Proposed Temporary Open Storage and Warehouse for Storage of Vehicle Parts with Ancillary Vehicle Repair Workshop for a Period of 3 Years at Lots 1358 RP & 1359 in D.D.78, Lin Ma Hang Road, Ta Kwu Ling, N.T.

**Proposed Temporary Open Storage and Warehouse for Storage of Vehicle Parts
with Ancillary Vehicle Repair Workshop for a Period of 3 Years
at Lots 1358 RP and 1359 in D.D. 78, Lin Ma Hang Road,
Ta Kwu Ling North, New Territories
Application No. A/NE-TKLN/114**

Response to Comments

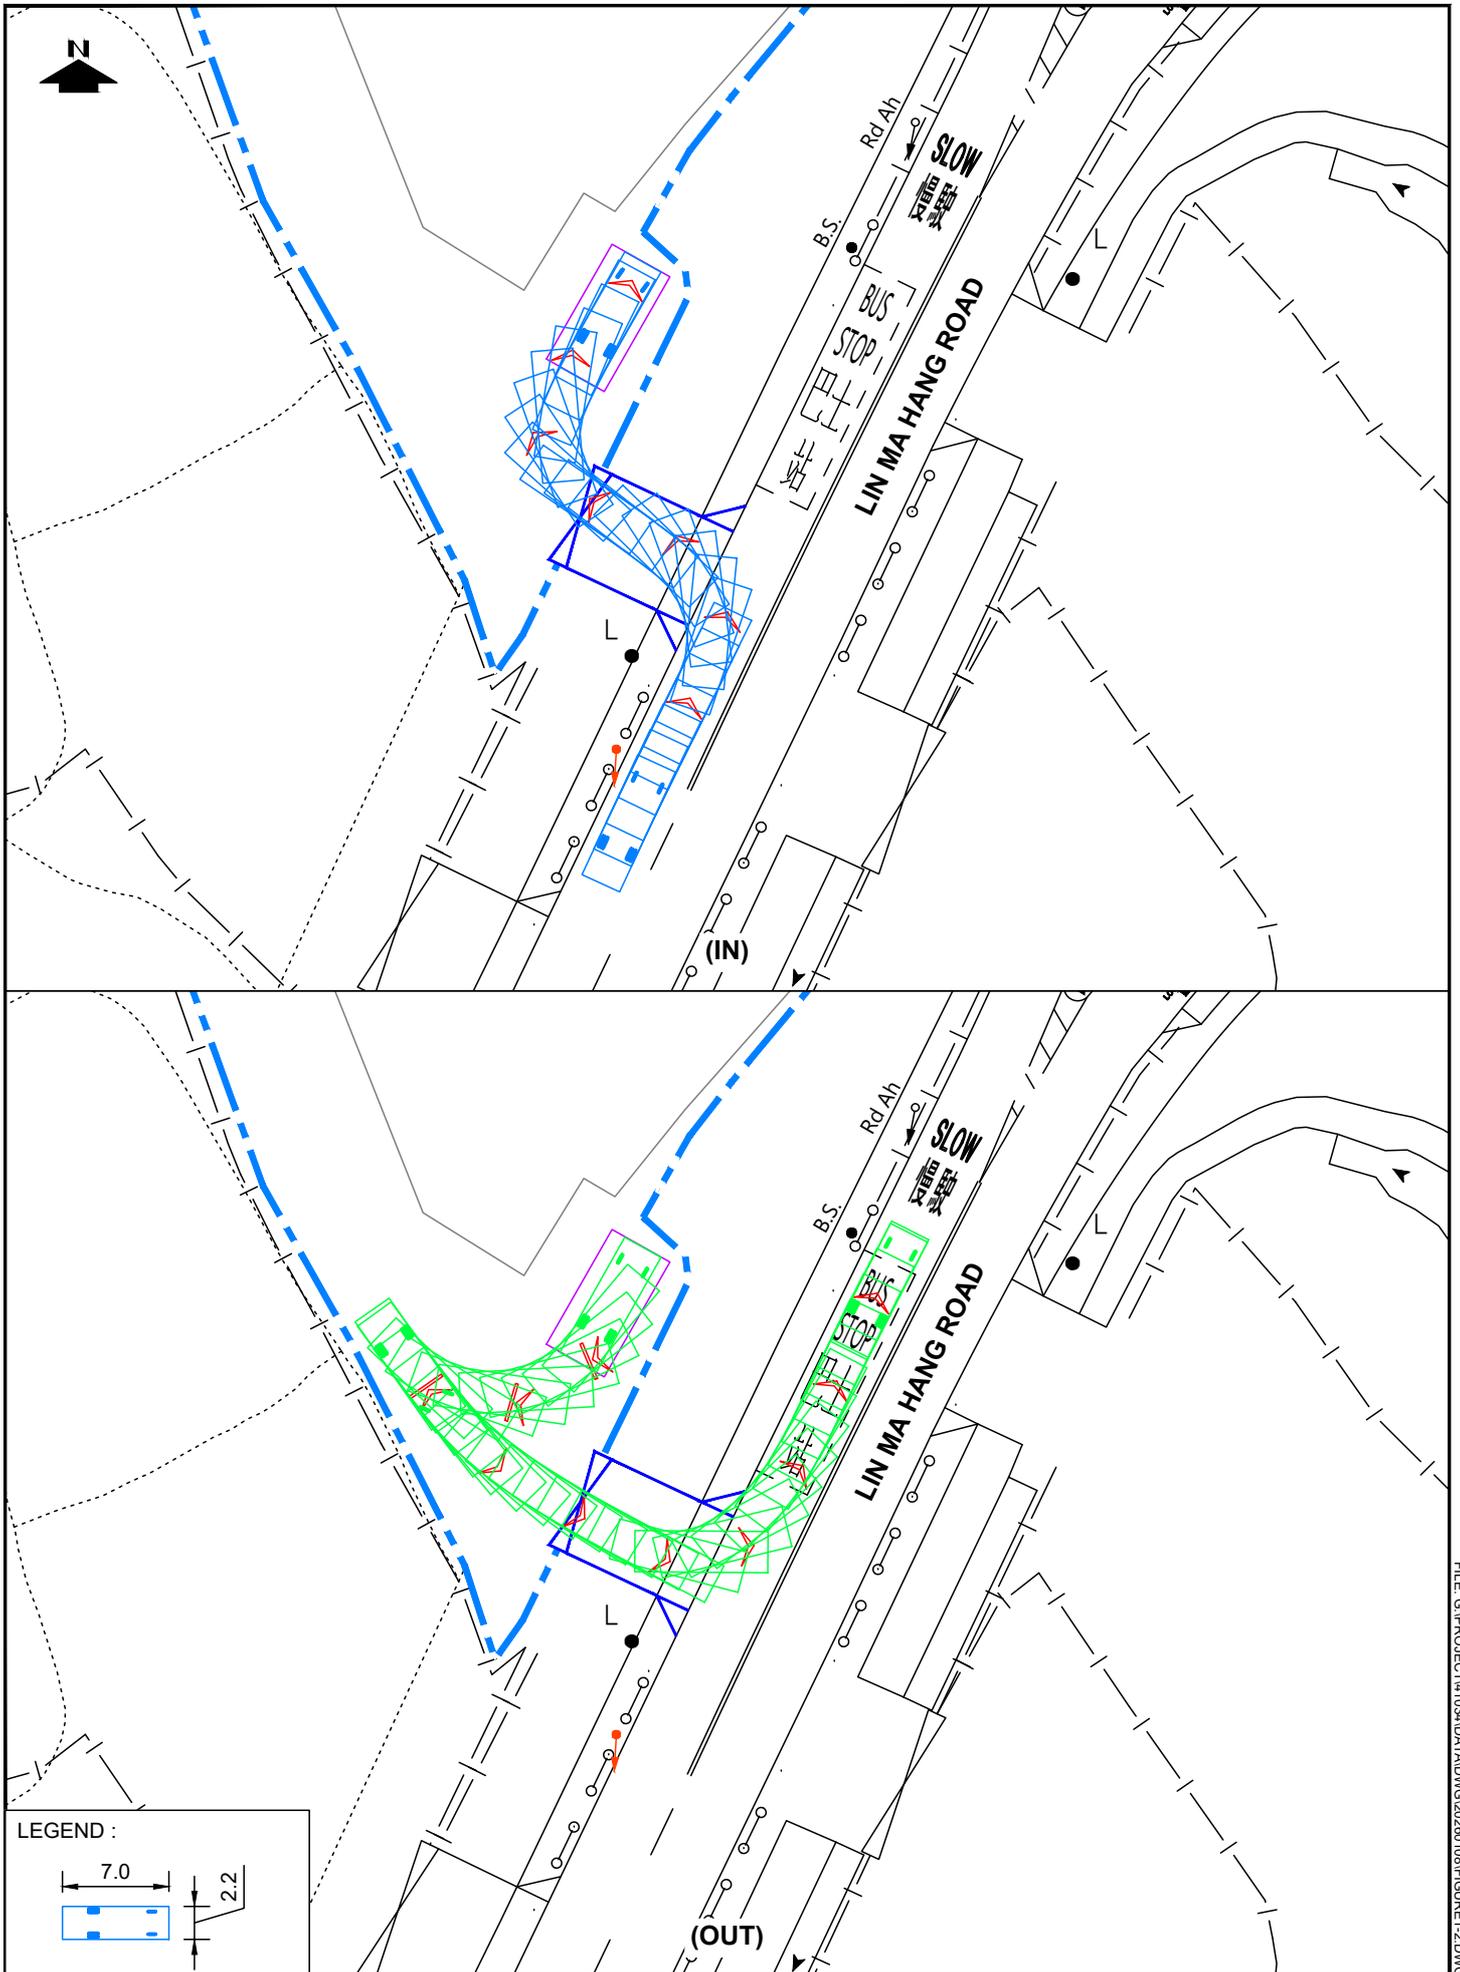
Comments	Responses
Comments from Transport Department via Planning Department's email	
1. The applicant shall provide a proposal on the vehicular access arrangement including the run-in / out design for the vehicles leaving / entering the development;	Noted. Please refer to Figure 1 attached for the proposed vehicular access arrangement.

2. The applicant shall take account of the existing on-street bus stop in adjacent to the site, and provide a proposal to avoid affecting passenger waiting area and the bus operation;	<p>The proposed vehicular access is being positioned to avoid the conflict with the existing on-street bus stop as shown in Figure 1. As the proposed location is not near the front of the bus stop where the passengers will gather, the impact on passenger waiting area and bus operation is minimal.</p> <p>At the same time, there is only 1 bus route (i.e. 79K) at the concerned on-street bus stop with a frequency of at most 3 trips per hour. While the bus stop is the third last stop of bus route which is anticipated to serve mainly passengers alighting, the number of passengers waiting for boarding would be small.</p>

4. The applicant shall advise the provision of pedestrian facilities and management measures to ensure pedestrian safety;	Revolving lanterns will be provided at both sides of the vehicular access to warn the pedestrians when there is a vehicle exiting from the subject site.

PROJECT TITLE	PROPOSED TEMPORARY OPEN STORAGE AND WAREHOUSE FOR STORAGE OF VEHICLE PARTS WITH ANCILIARY VEHICLE REPAIR WORKSHOP FOR A PERIOD OF 3 YEARS AT LOTS 1358 RP AND 1359 IN D.D. 78, LIN MA HANG ROAD, TA KWU LING NORTH, NEW TERRITORIES
DRAWING TITLE	SWEPT PATH ANALYSIS - LGV

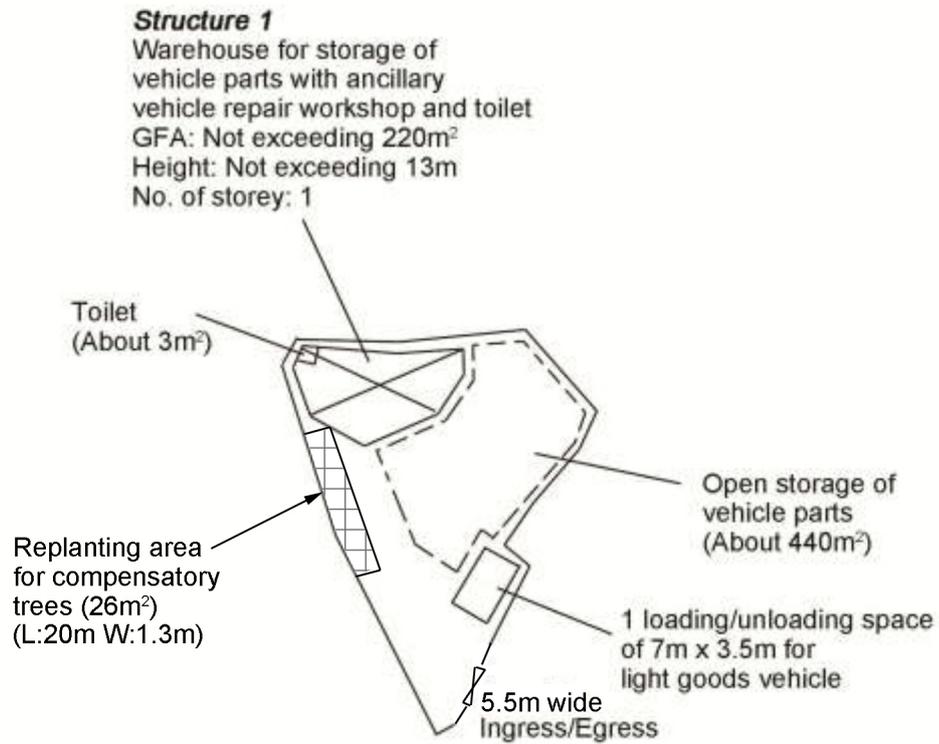
3. The applicant shall demonstrate the satisfactory maneuvering of the goods vehicles entering and exiting the subject site, maneuvering within the subject site and into / out of the loading/unloading space, preferably using the swept path analysis;	Noted. Swept path analysis is conducted to demonstrate the manoeuvring of a light goods vehicle entering and exiting the subject site, maneuvering within the subject site as well as moving into / out of the loading/unloading space. Please refer to Figure 2 attached for details.
